# Access Compliance Report

## Public Rights-of-Way

Intersection ID: 45515	Main Street: COTTON_PRESS_RD	Cross Street: HEDGEROW_PARK_RD	Location: W
ADA ID: 8CA7440DA3CF	Ramp Type: PerpDiag	Initial Pass/Fail: Fail	Overall Compliance: No
Severity Score: 47.5			
Codes/Mitigation Info/Possible Solution		Field Measurements/Component Compliance

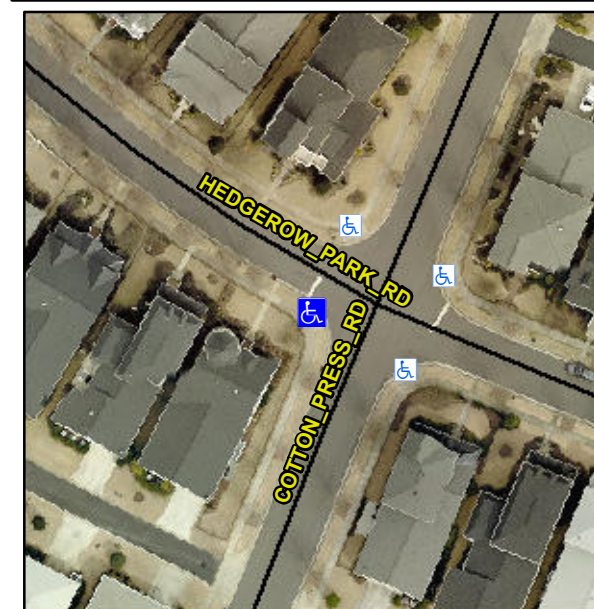
**Not Found, R304.5.1, R304.2.2**

Compliance	Description	Data	Compliance	Description	Data
N/A	Ramp Length (in)	72.0	No	Ramp Slope (%)	10.2
No	Ramp Width (in)	28.0	Yes	Ramp XSlope (%)	0.9
N/A	Flare Type LT	N/A	N/A	Flare Type RT	N/A
N/A	Flare Slope LT (%)	N/A	N/A	Flare Slope RT (%)	N/A
N/A	Flare Traversable LT?	N/A	N/A	Flare Traversable RT?	N/A
N/A	Landing Length (in)	N/A	N/A	DWS Provided?	N/A
N/A	Landing Width (in)	N/A	N/A	DWS Contrast?	N/A
N/A	Landing Slope (%)	N/A	N/A	DWS Length (in)	N/A
N/A	Landing X Slope (%)	N/A	N/A	DWS Full Width?	N/A
N/A	Landing Curb? (Y/N)	N/A	N/A	DWS Offset (in)	N/A
N/A	Shared Landing?	N/A			
N/A	Gutter Ponding?	N/A	N/A	Gutter Slope (%)	N/A
N/A	Gutter Lip Ht (in)	N/A	N/A	Gutter X Slope (%)	N/A
N/A	Painted X Walk1?	No	N/A	Painted X Walk2?	No
	X Walk 1 Direction	To SE		X Walk 2 Direction	To NE
N/A	X Walk 1 Width (in)	N/A	N/A	X Walk 2 Width (in)	N/A
	X Walk 1 Slope (%)	0.6		X Walk 2 Slope (%)	3.5
	X Walk 1 X Slope (%)	1.8		X Walk 2 X Slope (%)	0.3

**Remove & Replace Curb Ramp With Two New Directional Ramps or Equivalent.**
